Subject : MHI Decision Gate 3 review report draft

Manitoba Hydro International's  
**Decision Gate 3 review of the  
Muskrat Falls and Labrador Island HVdc Link  
and the Isolated Island options**

**DRAFT**

August 2, 2012

**Figure 8: Typical HVdc Transmission Guyed Tangent Structures**

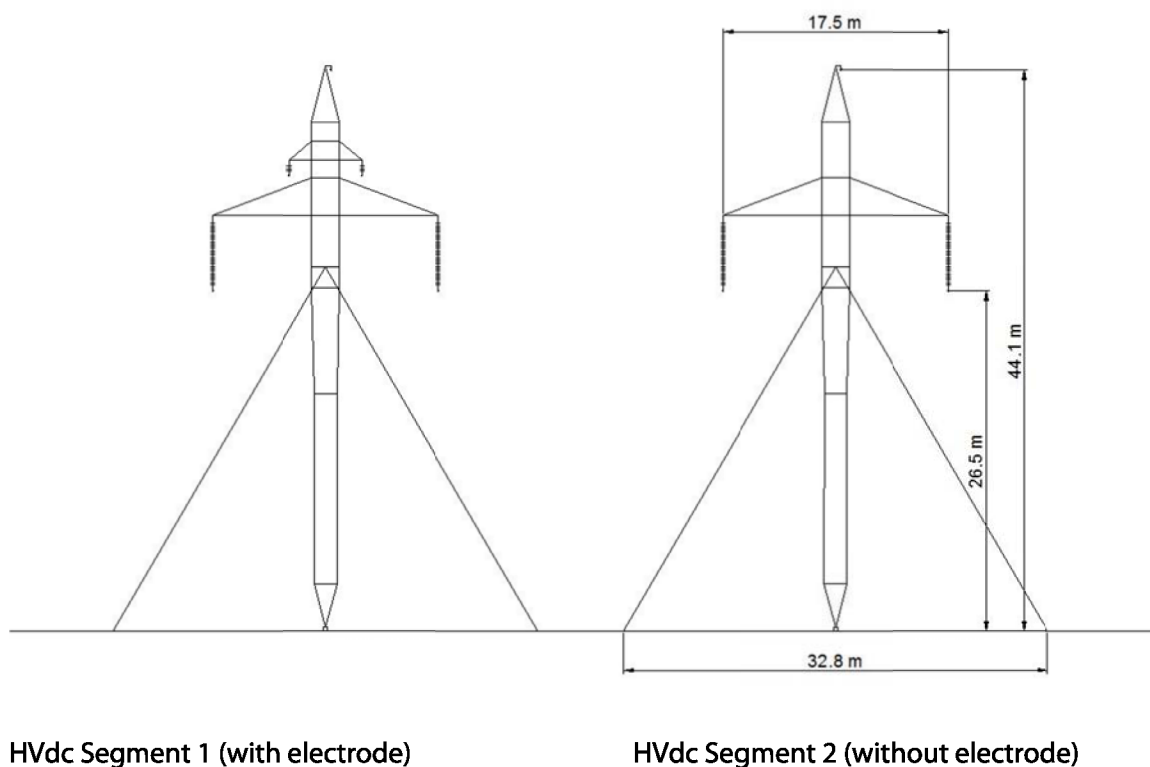
*Typical guyed tangent tower which comprise approximately 85% of the towers in the Labrador-Island HVdc transmission line.*

Nalcor's design controlled the various combined ice-and-wind loading to the line structures by reducing or increasing the ruling span in the 16 weather-zone regions. Generally, as the ice-and-wind-combined loading increased, the design ruling span was reduced. This is an acceptable approach to controlling the structure size and weight, and ultimately construction and logistics costs.

*Figure 9: Design Spans for Ice Loading*

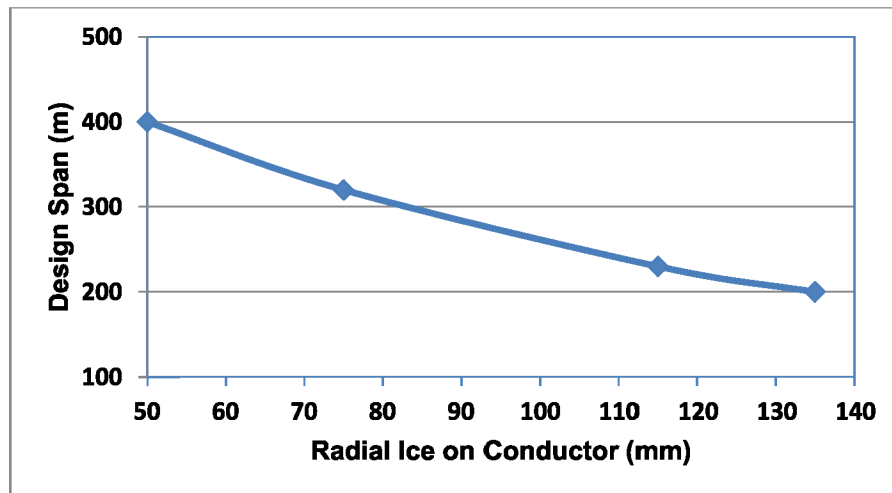
MHI has reviewed the various ice-and-wind loading cases and required structure families and has determined Nalcor's design approach, given the severity and wide range of weather cases found along the transmission line route, is a reasonable and cost-effective methodology.

*Figure 10: Strait of Belle Isle Marine Crossing Location*

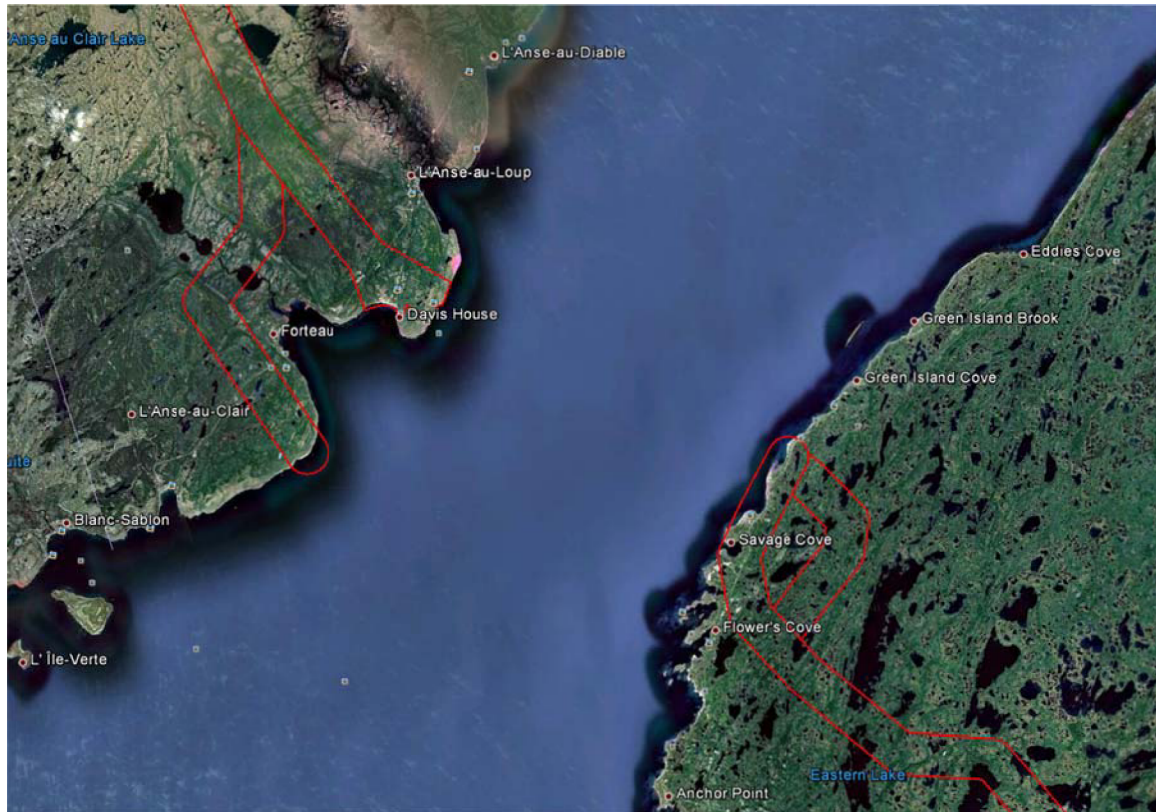
Further refinement of the route is being investigated to firm up the shore approaches, the horizontal directional drilling (HDD) techniques, the sea floor routing, the cable-laying technology, and the rock berm placement. There are ongoing studies of the currents and tides in the Strait, and continued surveillance of iceberg movements and roll rates in the vicinity. An observation tower has been erected to track movement of icebergs through the Strait and record actual roll rates. The status of these works was reviewed during meetings with Nalcor and the Engineer responsible for this segment of the project.
